DIST.	COUNTY	ROUTE	KILOMETER POST TOTAL PROJECT	SHEET NO.	TOTAL SHEETS
04	SF	80	13.2/13.9	456R2	1204

MARK	DATE	DESCRIPTIONS	BY	CH'D	CCO#
2	05/04/07	W2 CAP BEAM ISD RESOLUTION	JD	AS	34S1
1	07/21/06	W2 CAP BEAM ISD	JD	NV	23

CONTRACT CHANGE ORDER NO. ____
SHEET ___ OF ___

DETAIL A (see Note 1)
1:25

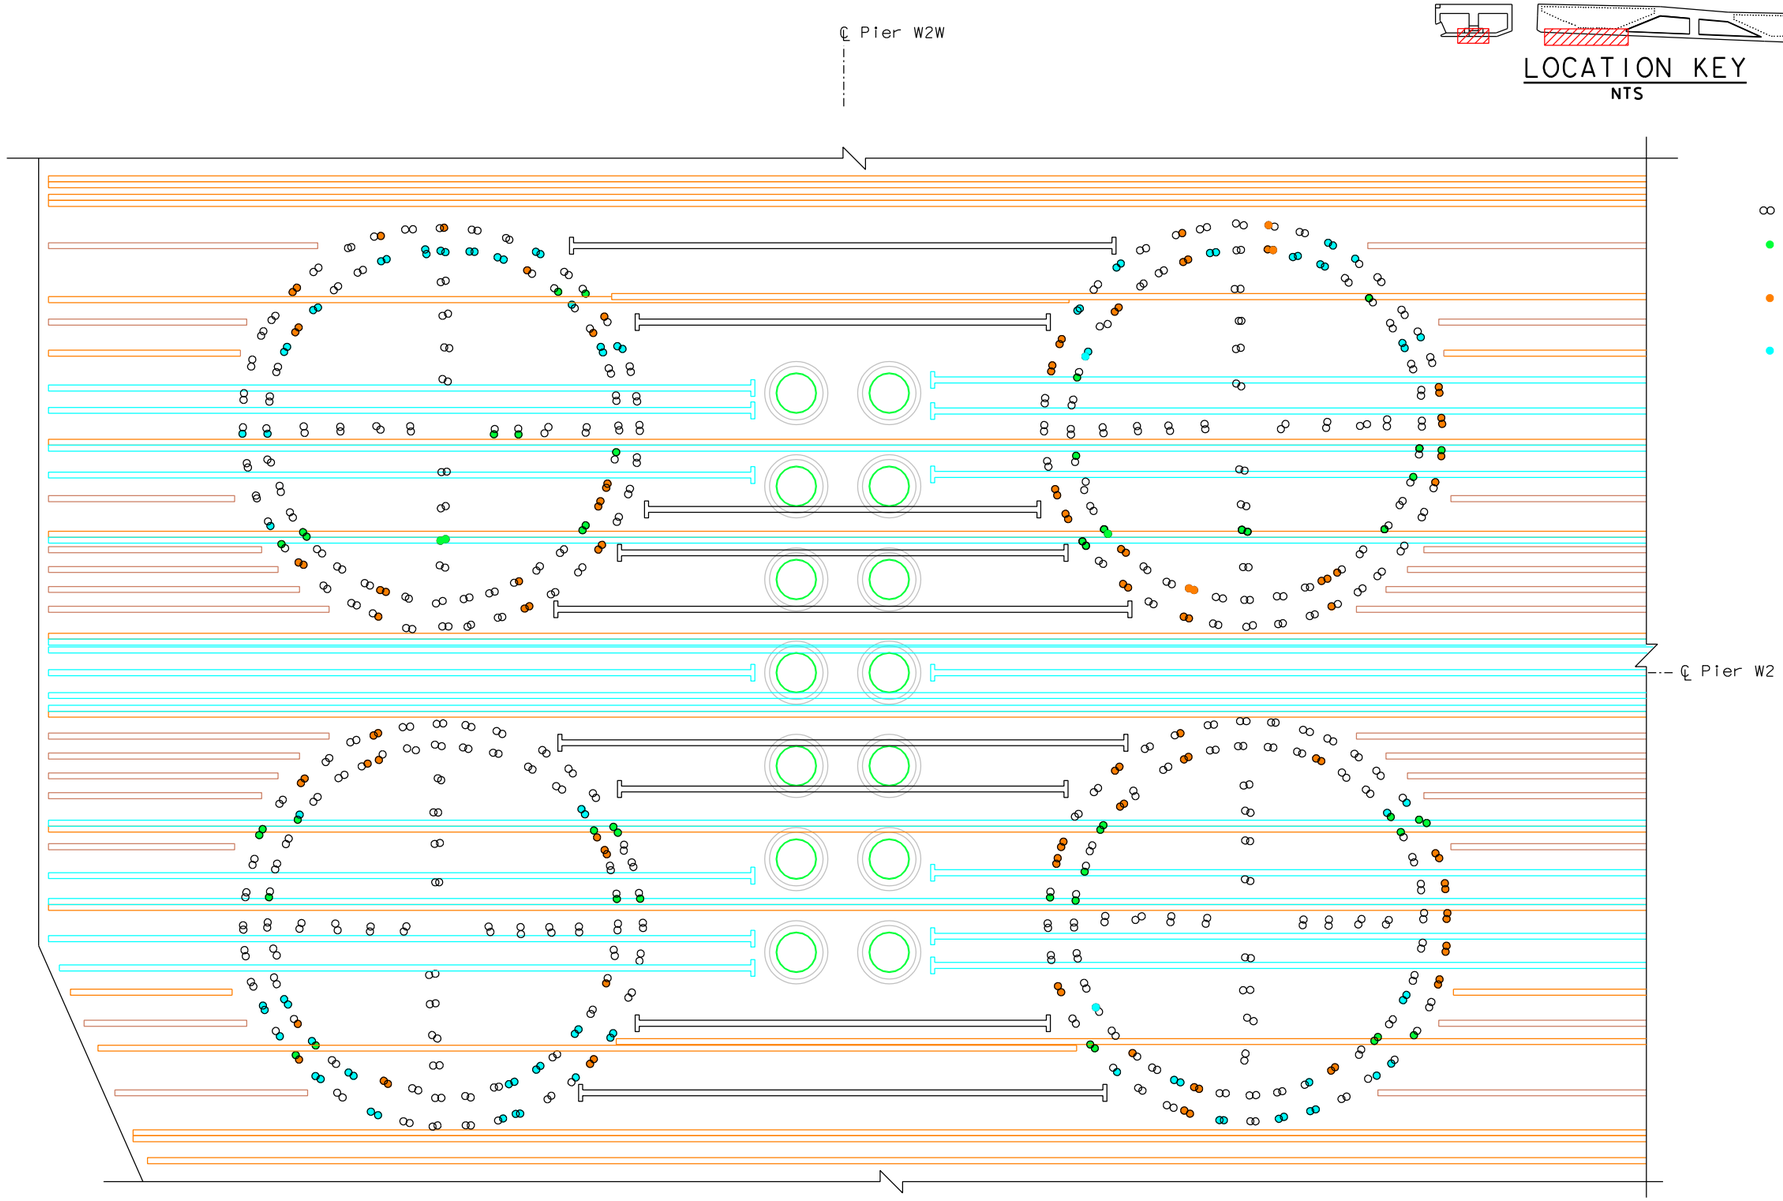
1. Transverse bottom mat reinforcement layout reflects as-surveyed vertical pier reinforcement locations within Region 4. The revised layout reflects anticipated column reinforcement cut-offs based on the survey data provided by the Contractor.

DETAIL A'
1:25
(see Note 1)

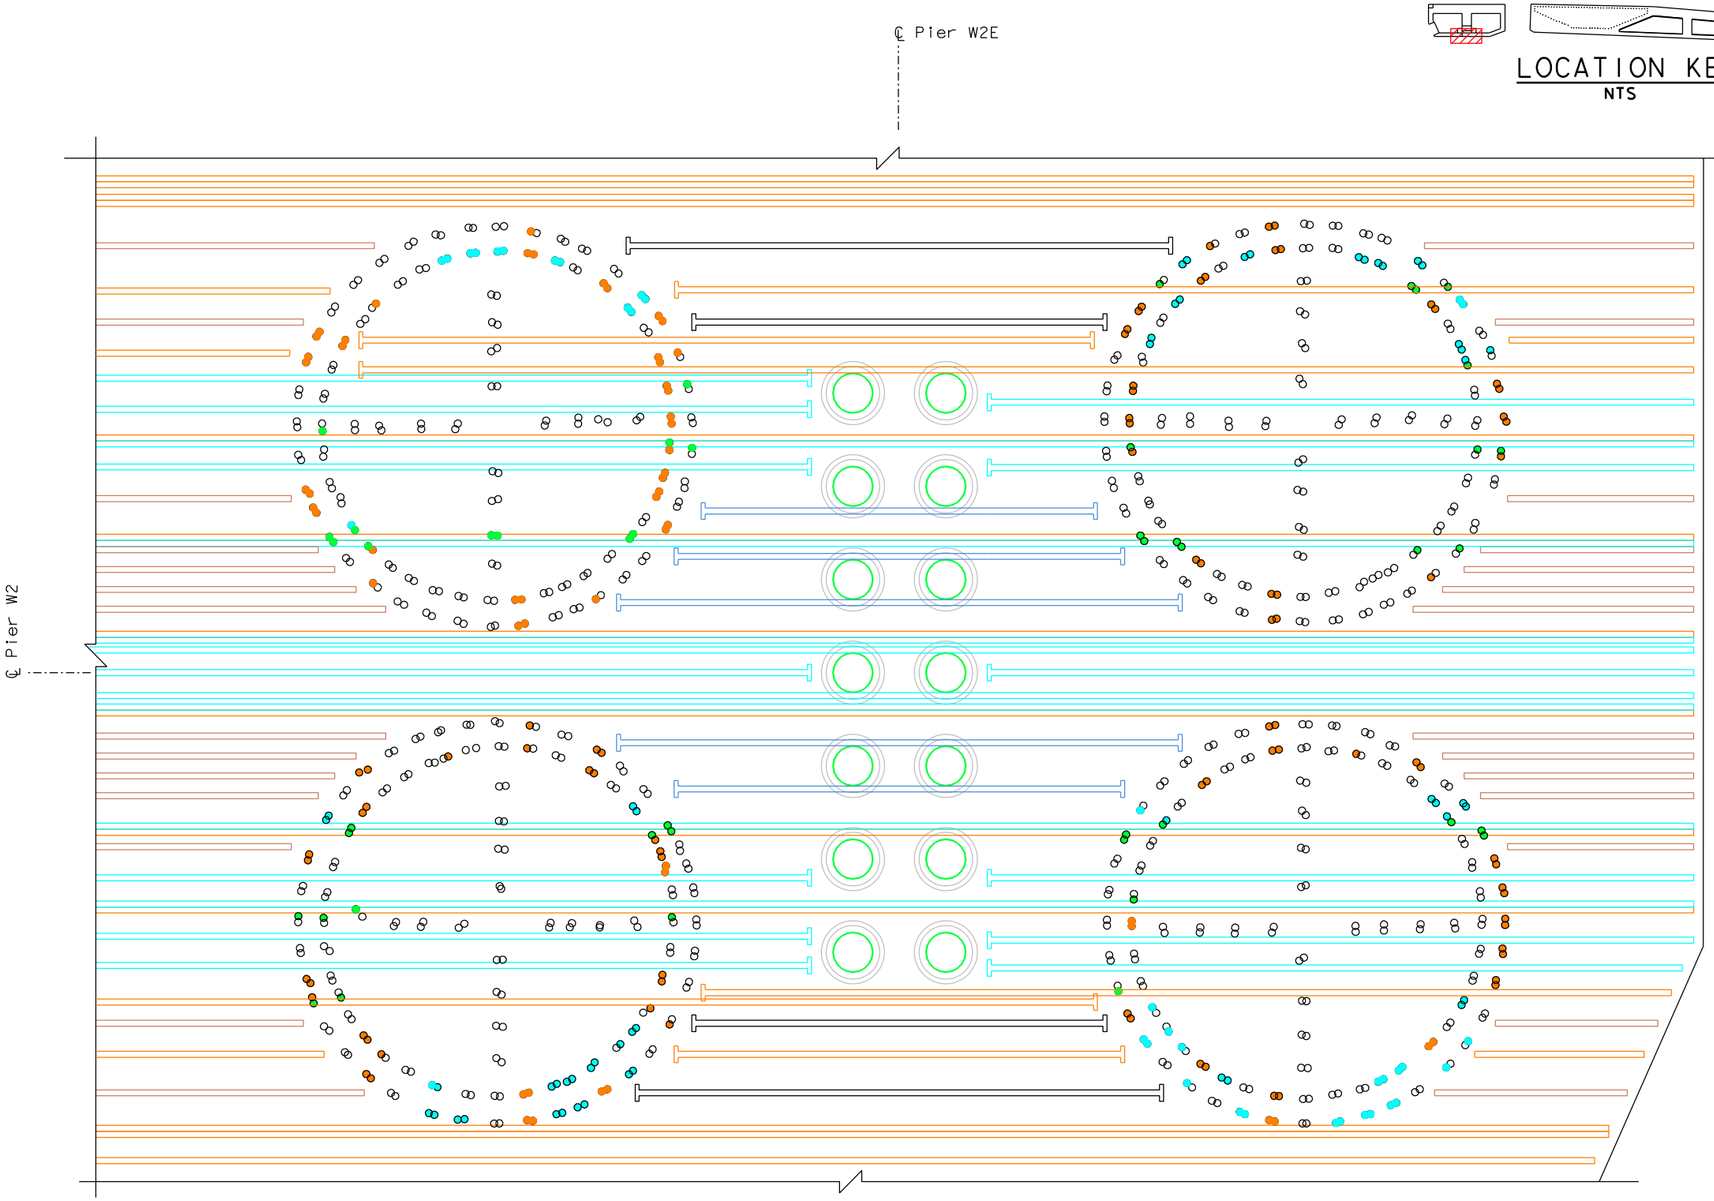
1. Transverse bottom mat reinforcement layout reflects as-surveyed vertical pier reinforcement locations within Region 4. The revised layout reflects anticipated column reinforcement cut-offs based on the survey data provided by the Contractor.

4 SECTION B-B
1:20

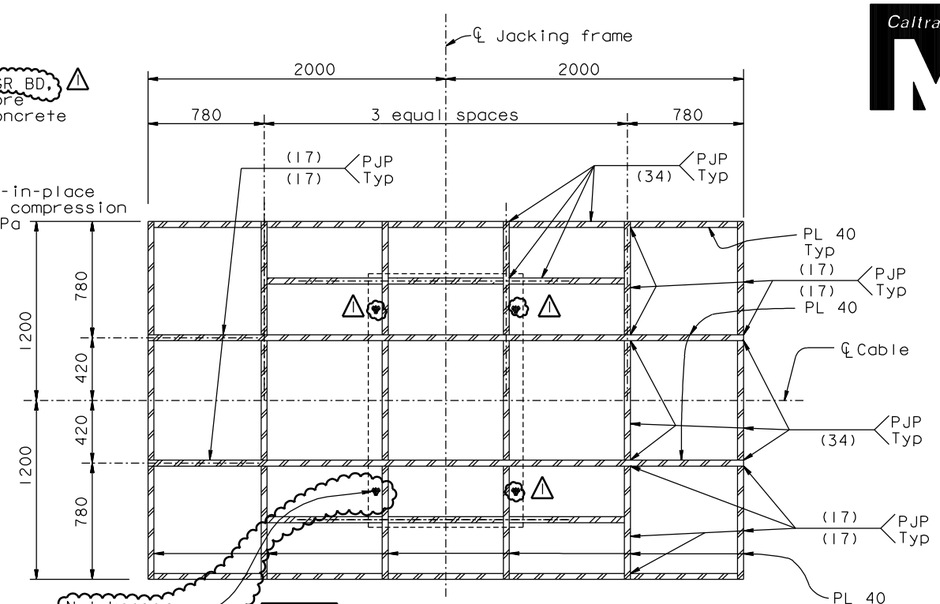
4 REVISED PER ADDENDUM NO. 4 DATED DECEMBER 9, 2005

4 **SECTION B-B** Cantilever truss (Between PP 7 & PP 8)
1:20

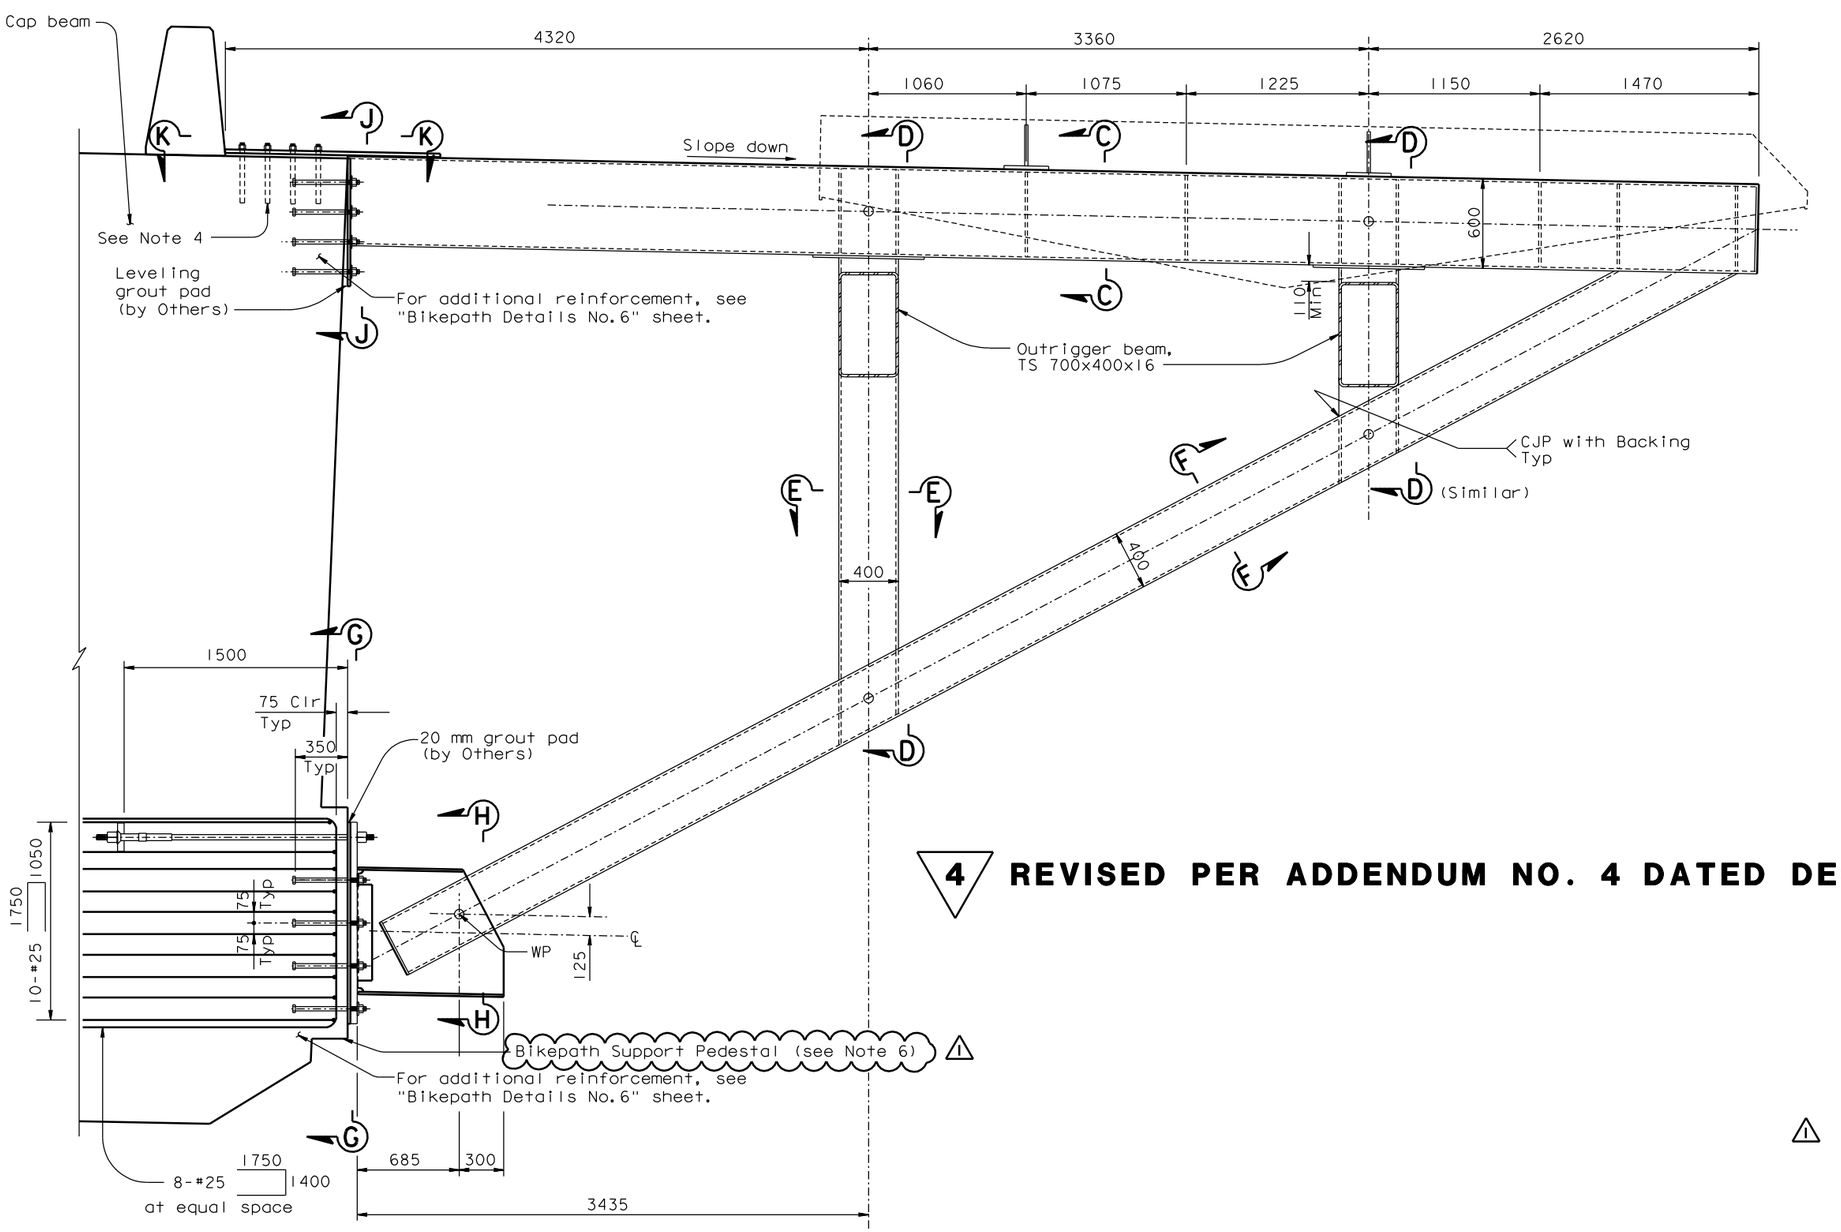
4 **REVISED PER ADDENDUM NO. 4 DATED DECEMBER 9, 2005**
